PCN-20210611 TE0729-02 eMMC Change

Company	Trenz Electronic GmbH	
PCN Number	PCN-20210611	
Title	TE0729-02 eMMC Change	
Subject	BOM change	
Issue Date	2021-08-05

This change affects all Trenz Electronic TE0729 SoMs of revision 02: TE0729-02

Locate eMMC (U5) on bottom side of PCB:

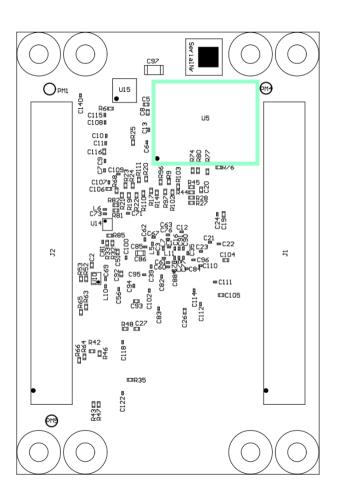
#1 Change eMMC (U5) from IS21ES08G-JCLI to SDINBDG4-8G-XI2

Reason: Distributor informed about unforeseeable immediate EOL of parts. No official documents form manufacturer are available. No LTB, already confirmed orders were cancelled by distributor/manufacturer.

Impact: None. Replacement has same capacity as used on corresponding affected variant. Reference designs for vivado versions 2019.2 and 2020.2 were tested and work properly without any changes.

old	new	
IS21ES08G-JCLI	SDINBDG4-8G-XI2
